Access Compliance Report

Public Rights-of-Way

(Curb Ramps)

Intersection ID: 43349	Main Street: FORESTRIDGE COMMONS DR	Cross Street: FORESTRIDGE COMMONS DR	Location: SW
ADA ID: F0F5B1C1AAEA	Ramp Type: PerpDiag	Initial Pass/Fail: Fail	Overall Compliance: No
Severity Score: 21.25			
Codes/Mitigation Info/Possible Solution		Field Measurements/Component Compliance

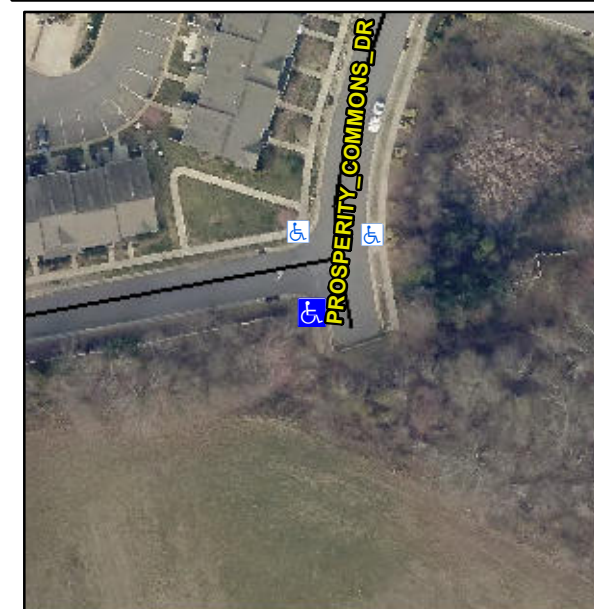
Compliance	Description	Data	Compliance	Description	Data
N/A	Ramp Length (in)	47.0	No	Ramp Slope (%)	10.2
No	Ramp Width (in)	40.0	Yes	Ramp XSlope (%)	1.9
N/A	Flare Type LT	N/A	N/A	Flare Type RT	N/A
N/A	Flare Slope LT (%)	N/A	N/A	Flare Slope RT (%)	N/A
N/A	Flare Traversable LT?	N/A	N/A	Flare Traversable RT?	N/A
N/A	Landing Length (in)	N/A	N/A	DWS Provided?	N/A
N/A	Landing Width (in)	N/A	N/A	DWS Contrast?	N/A
N/A	Landing Slope (%)	N/A	N/A	DWS Length (in)	N/A
N/A	Landing X Slope (%)	N/A	N/A	DWS Full Width?	N/A
N/A	Landing Curb? (Y/N)	N/A	N/A	DWS Offset (in)	N/A
N/A	Shared Landing?	N/A			
N/A	Gutter Ponding?	N/A	N/A	Gutter Slope (%)	N/A
N/A	Gutter Lip Ht (in)	N/A	N/A	Gutter X Slope (%)	N/A
N/A	Painted X Walk1?	No	N/A	Painted X Walk2?	No
	X Walk 1 Direction	To N		X Walk 2 Direction	To E
N/A	X Walk 1 Width (in)	N/A	N/A	X Walk 2 Width (in)	N/A
	X Walk 1 Slope (%)	0.7		X Walk 2 Slope (%)	2.1
	X Walk 1 X Slope (%)	0.8		X Walk 2 X Slope (%)	0.2

Remove & Replace Curb Ramp With Two New Directional Ramps or Equivalent.
